Inter Tribal Association of Arizona

May 31, 2022

Re: Inter Tribal Association of Arizona's Comments and Objections to ADEQ's Renewal and Amendment of the Resolution Copper Mining AZPDES Permit No. AZ0020389 (LTF No. 90471)

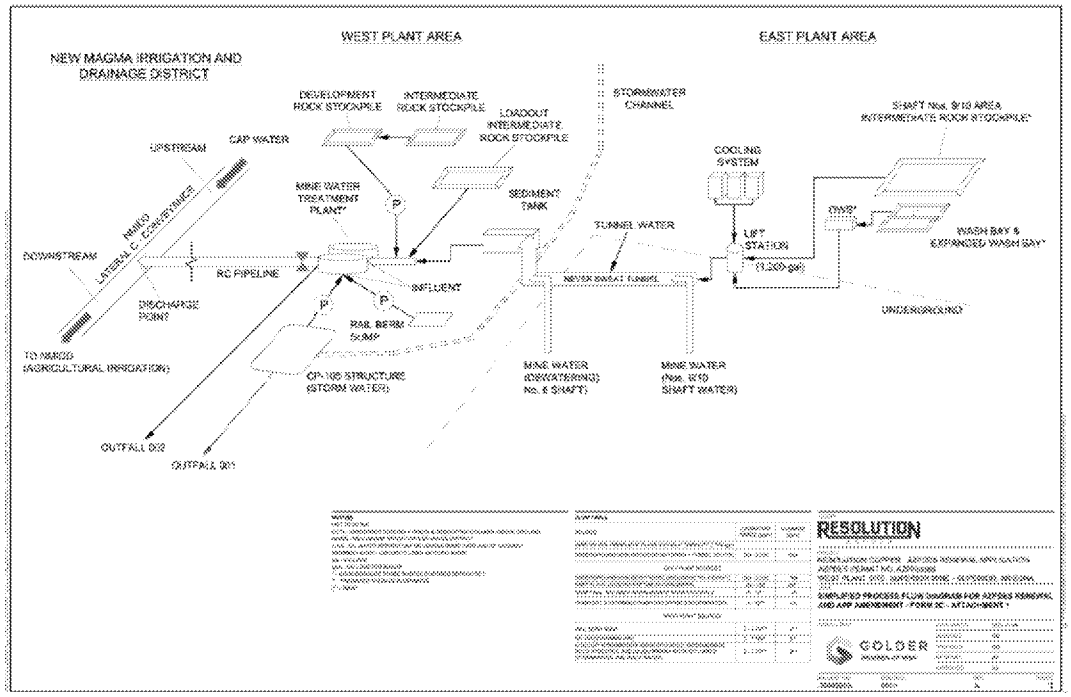
The Process Flow Diagram (shown on the following page) and Site Drainage Maps attached to the AZPDES Renewal Application[9] indicate that stormwater from across the West Plant site drains to and is collected in Collection Pond No. 105 (CP-105, formerly "Indian Pond") where it can then be discharged through Outfall 001. The West Plant Site is located north of Highway 60 in Superior, just north of Queen Creek, and drains south towards Queen Creek.

In sum, there are multiple sites located across the West Plant site which have the potential to convey pollutants and other constituents of concern into Queen Creek via discharge of stormwater at Outfall 001.

One key ongoing component of this remediation work is continued surface water monitoring, and a demonstration that the contamination source will not cause or contribute to an exceedance of surface water quality standards. A.R.S. § 49-175(B)(3).[11] Given the historic contamination from mining activities in the area, as well as ADEQ's duties under its administration of the AZPDES program, obtaining data on the quality of stormwater which could be drained into CP-105 and discharged through Outfall 001 is a key task.

However, Resolution notes that data on the quality of the stormwater which could be discharged through Outfall 001 "has not been obtained."[12] It also does not appear to be in the process of being obtained. Form 2F (dated July 22, 2021 at p.3, attached to AZPDES Permit Renewal Application) at Section 5.2 states: "No discharge through Outfall 001 has occurred therefore, no discharge data is available. Certification based on absence of active operations, completion of extensive reclamation work, diversion and containment control measures, and ability to pump water to MWTP." ADEQ appears to see no issue with this, since ADEQ did not require any additional information from Resolution Copper on this matter and they apparently failed to obtain this data independently.

The Fact Sheet (p.4) notes that a total of just two water quality samples have been collected. "In 2021, two water samples were collected and tested from water impounded at CP-105 during precipitation events less than a 10-year 24-hour event." No additional samples or data gathering activities are noted, and thus, this appears to be the entirety of water quality data collected for potential discharge through Outfall 001.

Given that stormwater in CP-105 may be discharged to Queen Creek via Outfall 001 without treatment, ADEQ must obtain and fully review baseline water quality data for the potential discharge at Outfall 001 post-reclamation to ensure compliance with the discharge limits imposed by the AZPDES permit. This is fundamental and nothing less than this should be permitted. It is also critical that the water quality data be developed on the influent to assure the successful operation of the MWTP. This is also a critical task, since the failure to fully apprehend the nature of the influent can result in treatment plant failure and a noncompliant discharge.

The East Plant Site is east of the Town of Superior. The Process Flow Diagram (shown on the prior page) indicates that waters from various sources at the East Plant Site are collected and transported to the Water Treatment Plant at the West Plant Site through the Never Sweat Tunnel.

The Application at Form 2C(I) states that contributing flows to Outfall 002 come from "Various Combined Sources" such as "mine dewatering, stormwater, etc." and references an attachment. Yet, the attachments do not distinguish, or specifically list these various sources. Furthermore, there is no evidence from the materials we have reviewed that any sampling of the feed water from these various sources has occurred.
